**DOCUMENT 00 91 02  
ADDENDUM NO. 2**

PROJECT: 2024 Anthony, Hopper and Kahla MS Renovations

FROM: Carolina Weitzman, A.I.A.  
Natex Corporation Architects  
447 Heights Blvd, Houston, TX 77007

Table with project details: Project Number: 23072, Date: 16 JANUARY 2025, Drawn By: JT / MR, ROOF FRAMING PLAN - AREA F, S2.01A

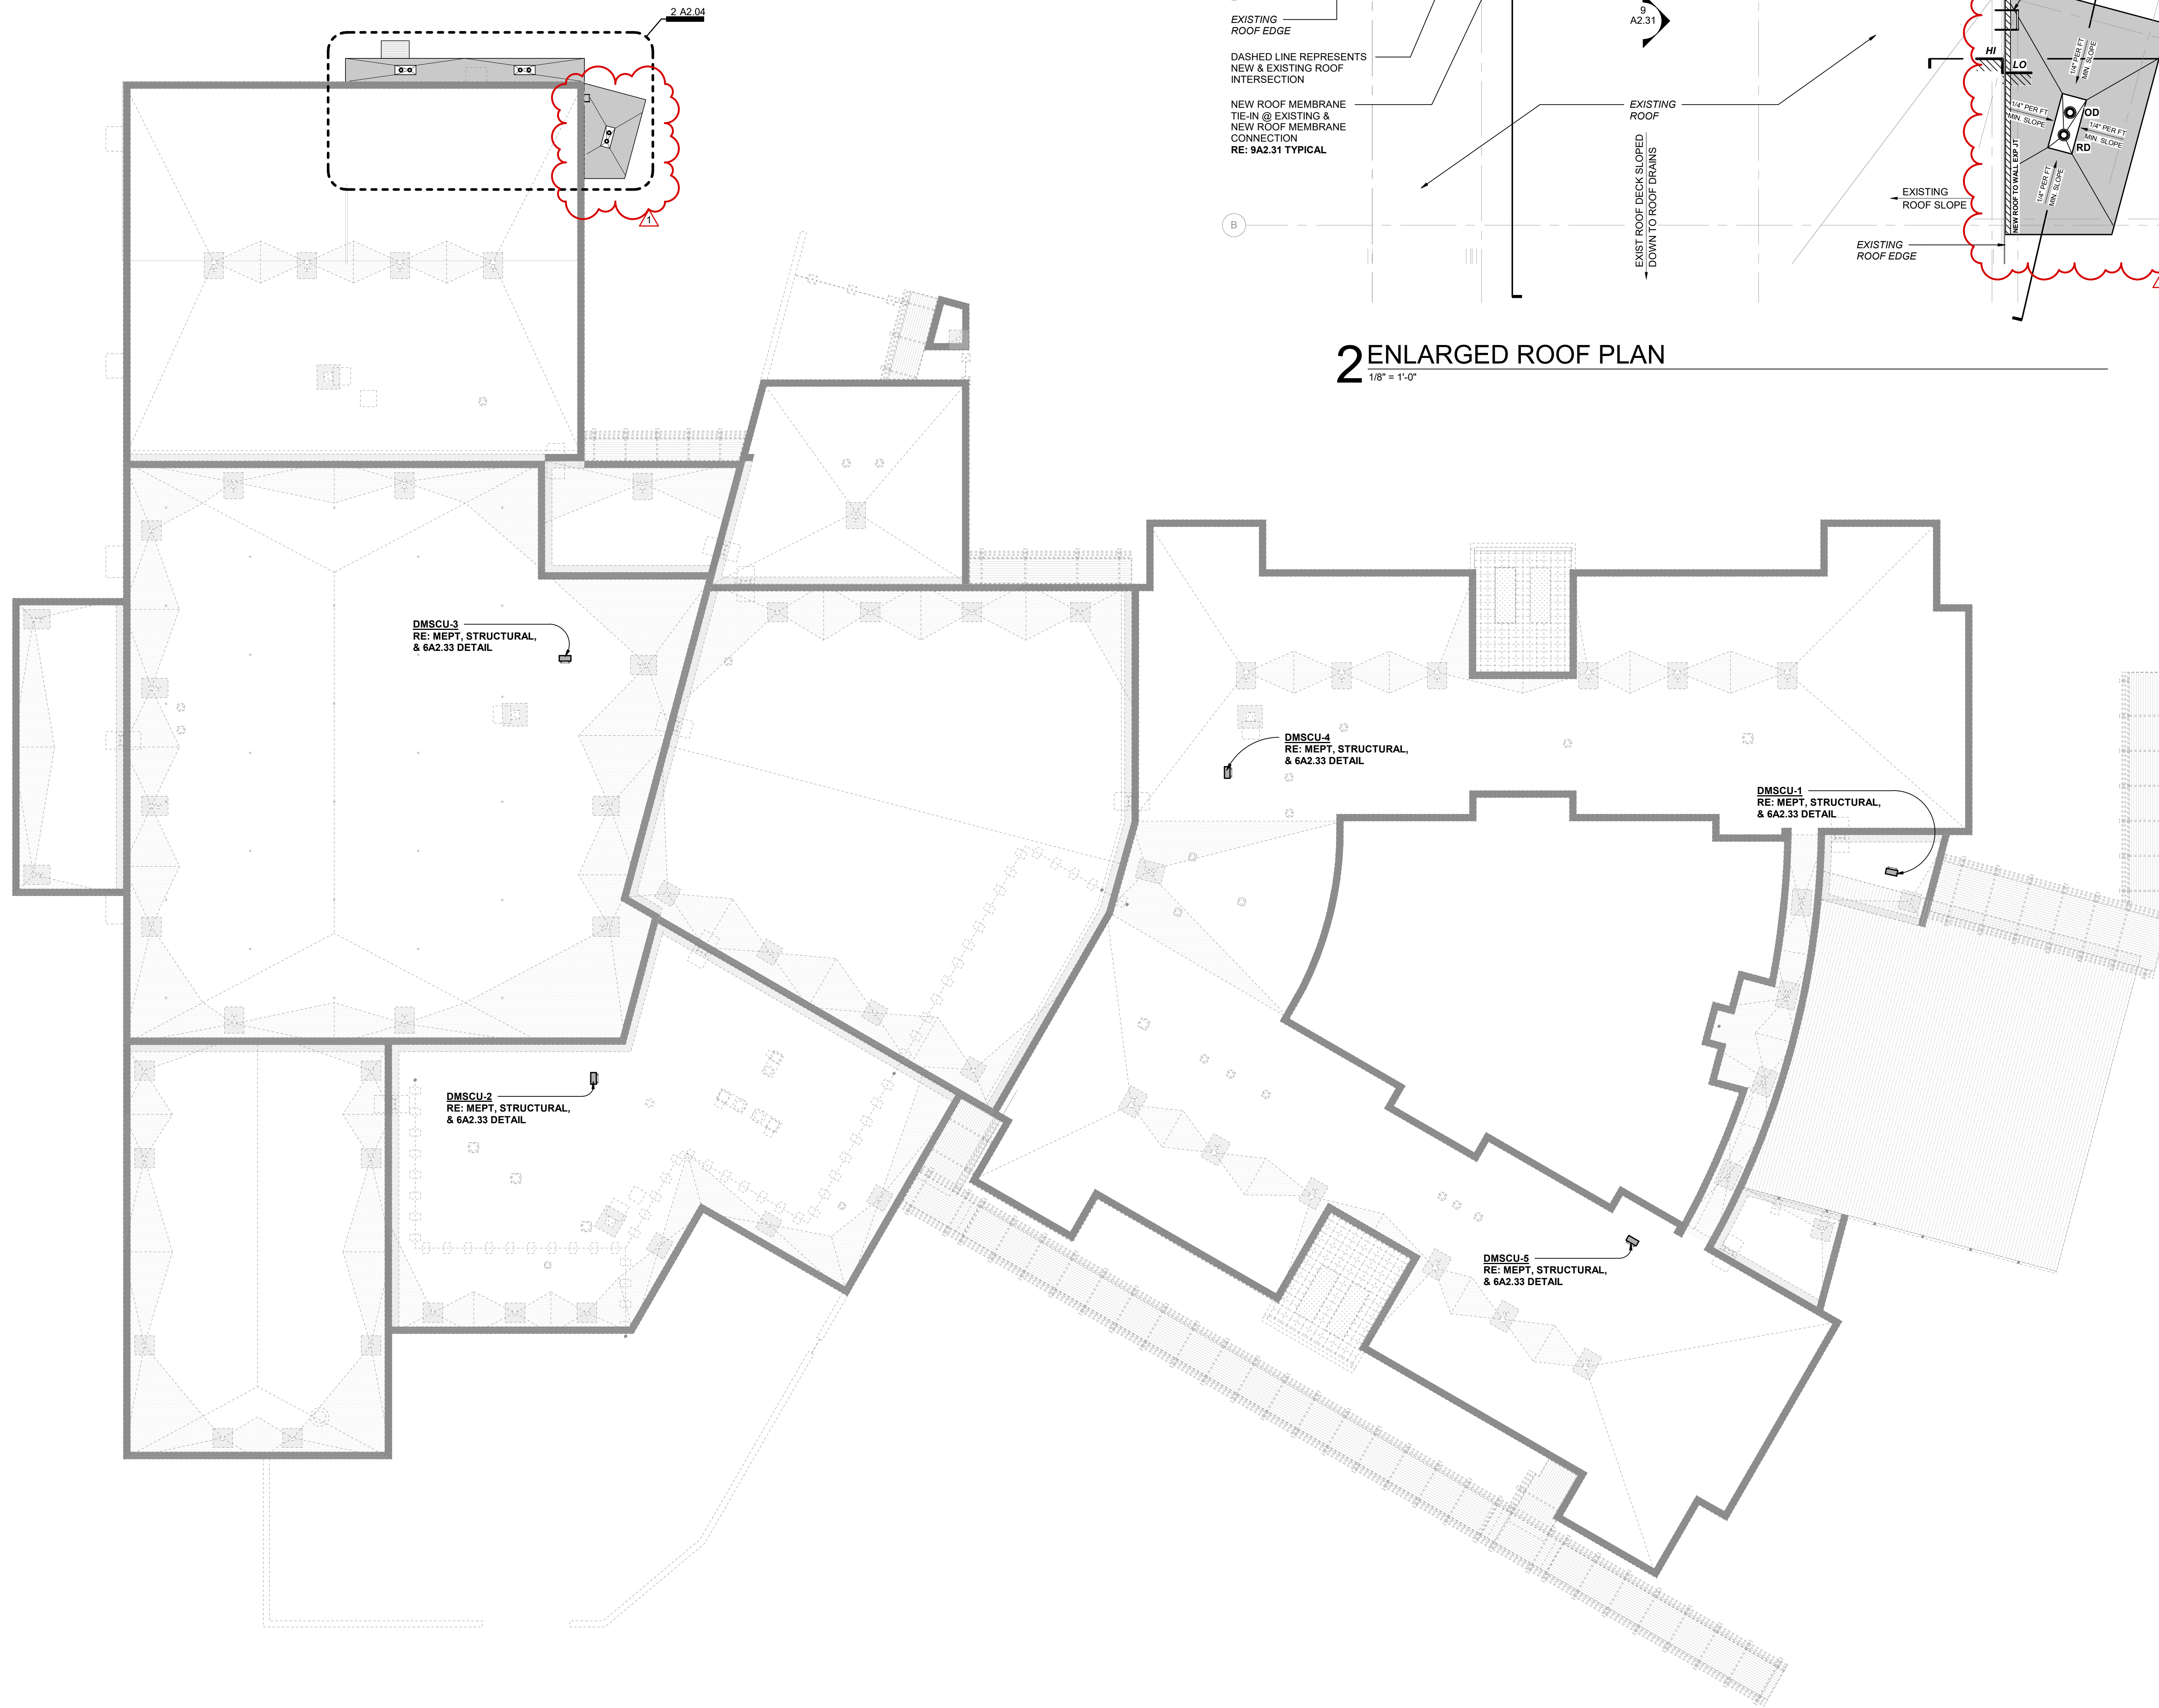
1. S1.01A – FOUNDATION PLAN - AREA F
  - a. Add Detail reference 14/S5.02
  - b. Refer to revised sheet
2. S2.01A – ROOF FRAMING PLAN – AREA F
  - a. Add Detail 14/S5.02

**A2.04**

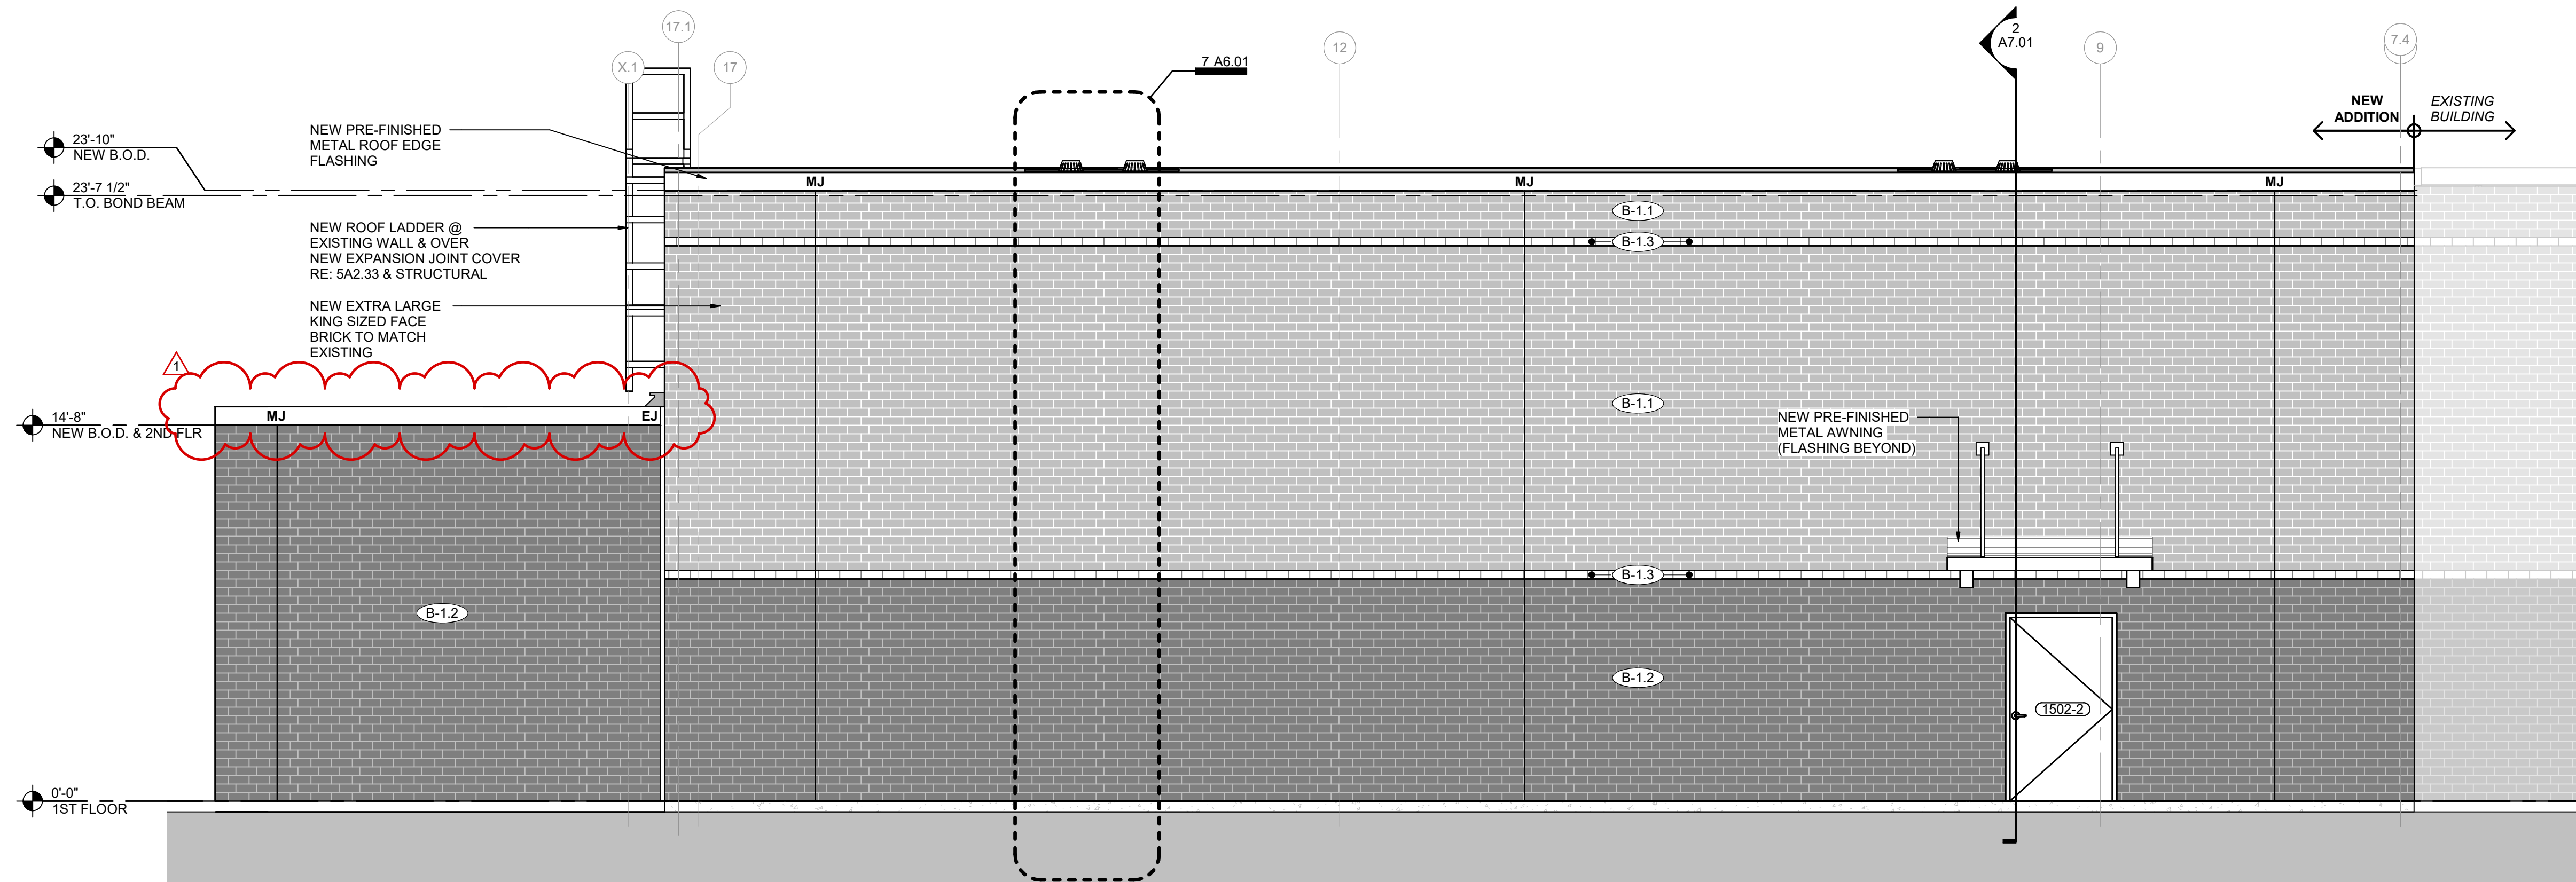
4. A2.04 – ROOF PLAN & ENLG ROOF PLAN
  - a. Detail 1 Overall Roof Plan – Show Roof @ new Stor. Addition.
  - b. Detail 2 Enlg. Roof Plan – Show Roof @ new Stor. Addition.

Project Number: 22084  
 Date: 29 DECEMBER 2024  
 Drawn by: LT  
**ELECTRICAL LIGHTING**  
**1ST FLOOR PLAN - AREA**  
**'C'**  
**E2.03**

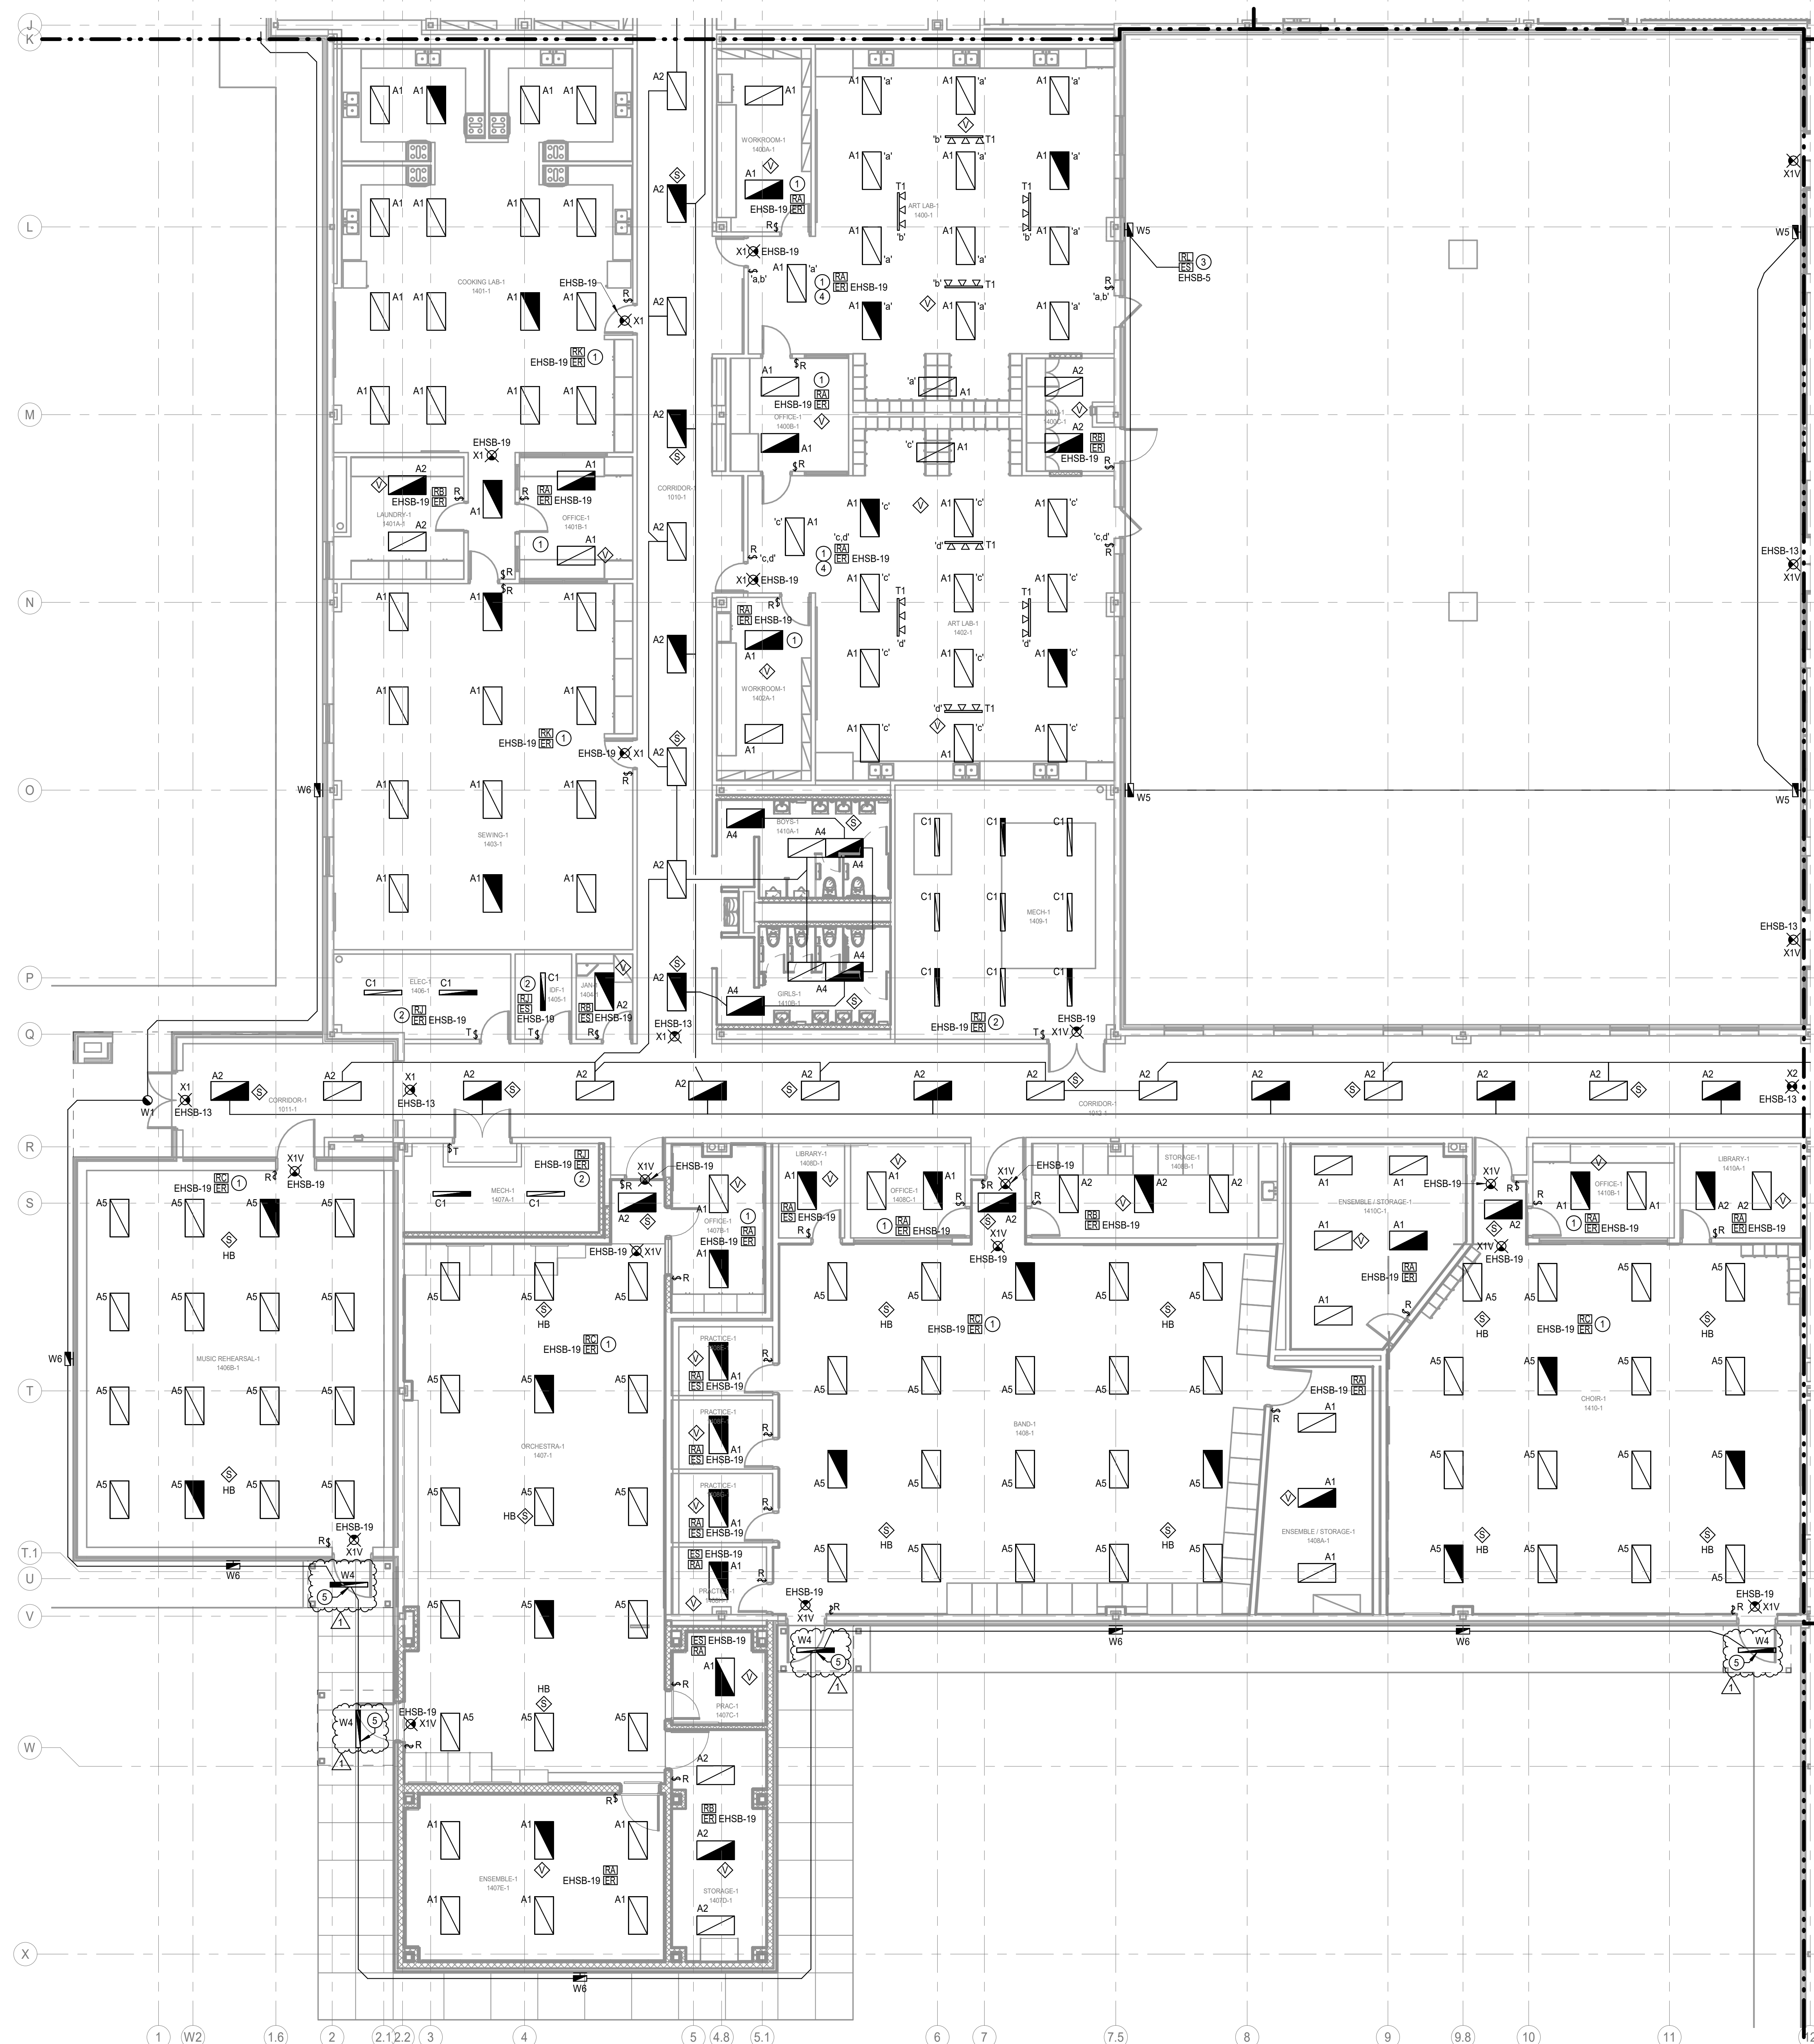
17. E2.03 ELECTRICAL LIGHTING 1ST FLOOR - AREA 'C'
  - a. Refer to revised sheet for new egress fixture.
